DEVELOPMENT REVIEW BOARD – SPEED MEMO						
	DRB CASE NO/PROJECT NO: 1006500 AGENDA ITEM NO: 19						
	SUBJECT:		•		~		
	Sketch Plat				·		
	ACTION REQUE	STED:					
•	REV/CMT: (X)	APPROVAL: ()	SIGN-OFF: ()	EXTN: ()	AMEND: ()		
	ENGINEERING	COMMENTS:					
P.O. Box 1293	An approved infras	tructure list is required f ed drainage report must b	or Preliminary Plat appears on file prior to Preli	proval. minary Plat approval			
Albuquerque	•						
New Mexico 87103							
www.cabq.gov							
	•			• •			
•	RESOLUTION:	•	.•	•			
	APPROVED; I	DENIED; DEFERRE	ED; COMMENTS	PROVIDED X; W	ITHDRAWN		
	DELEGATED: (S	EC-PLN) (SP-SUB) (S	SP-BP) (FP) TO: (UD) (CE) (TRANS) (PRKS) (PLNG		
	SIGNED: Bradley City En	L. Bingham gineer / AMAFCA Desig	gnee	DATE: MAY	ζ 30, 2007

DEVELOPMENT REVIEW BOARD TRANSPORTATION DEVELOPMENT Standard Comment Sheet

RE: Anderson Heights/Units 6 & 7/sketch

Re: Anderson Heights, Units 4 & 6 – Sketch Plat Review

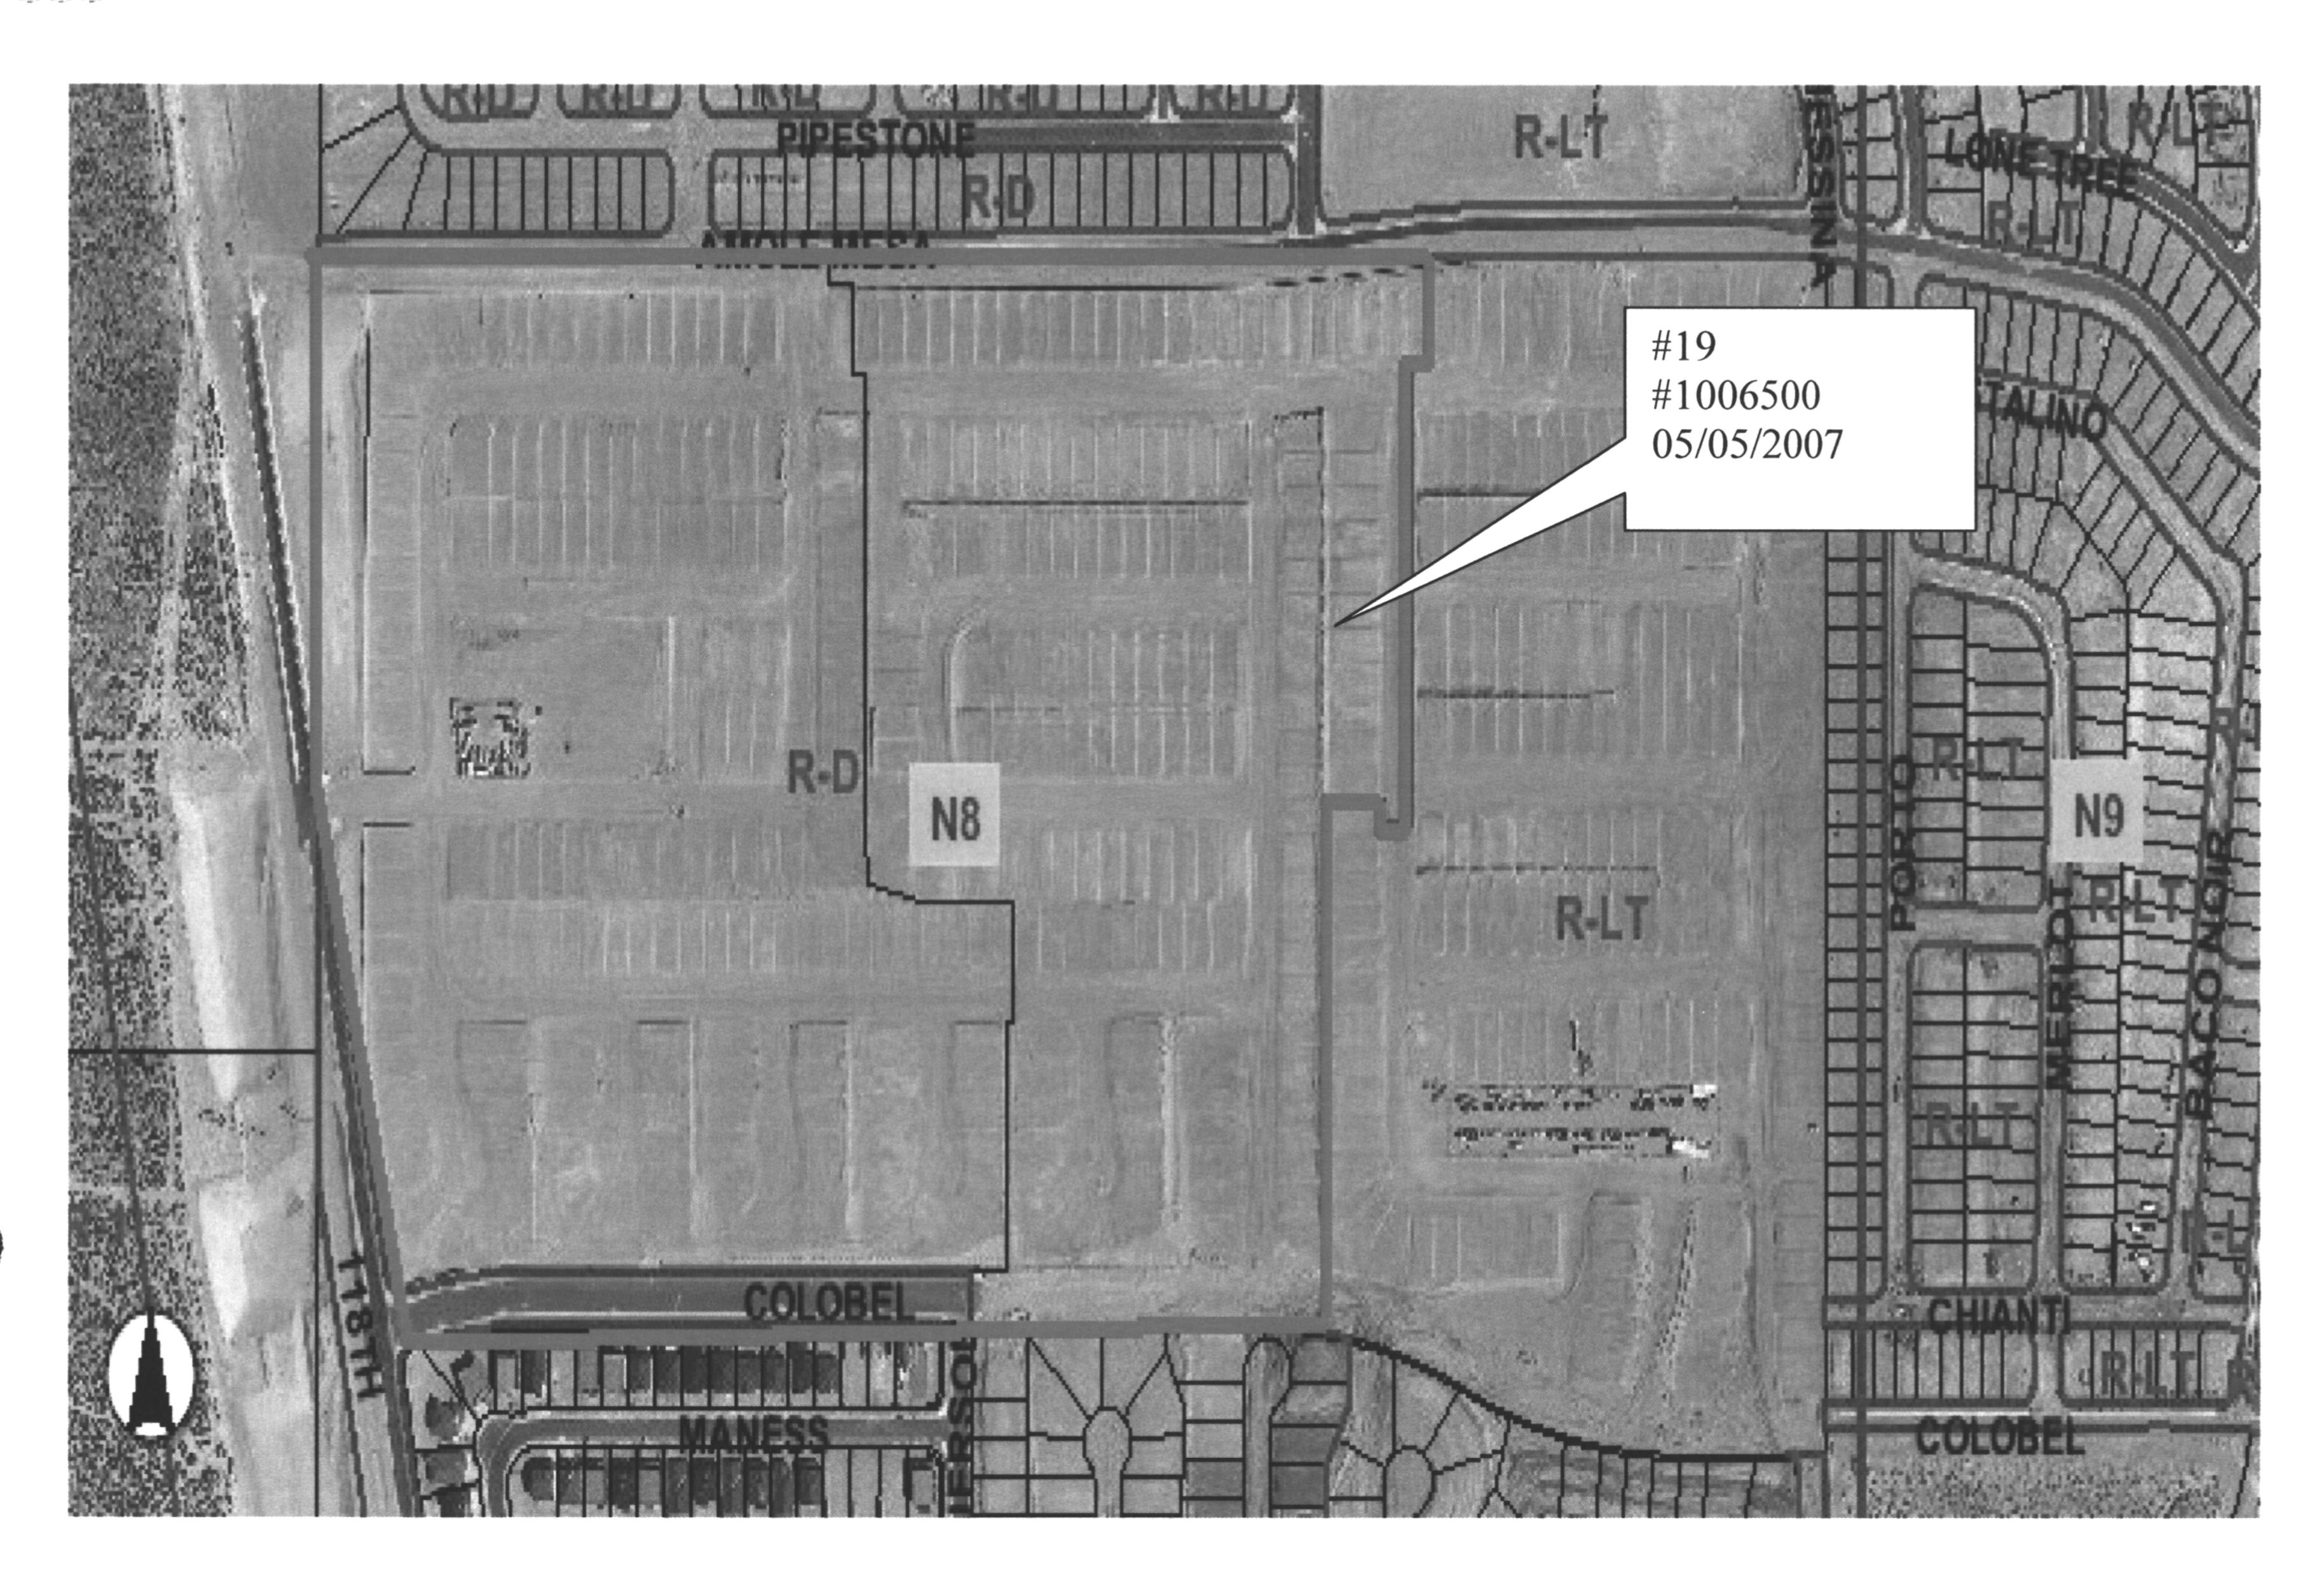
- 1) A traffic distribution map is needed to evaluate r/w widths. (Assuming the widths selected are to remove P1 designations?)
- 2) Unsure if a connection needs to be made through lots 36-106 or lots 30-112.
- 3) Where are the pedestrian connection to Amole Mesa and Colobel? (Major locals with housing backing up to such streets require pedestrian connections.) In addition, the maximum spacing for connecting streets to a major local is 850'.
- 4) Unsure how the x-section for the stub street will work.
- 5) Ensure that sight distance requirements onto Amole Mesa and Colobel are met. (~350')
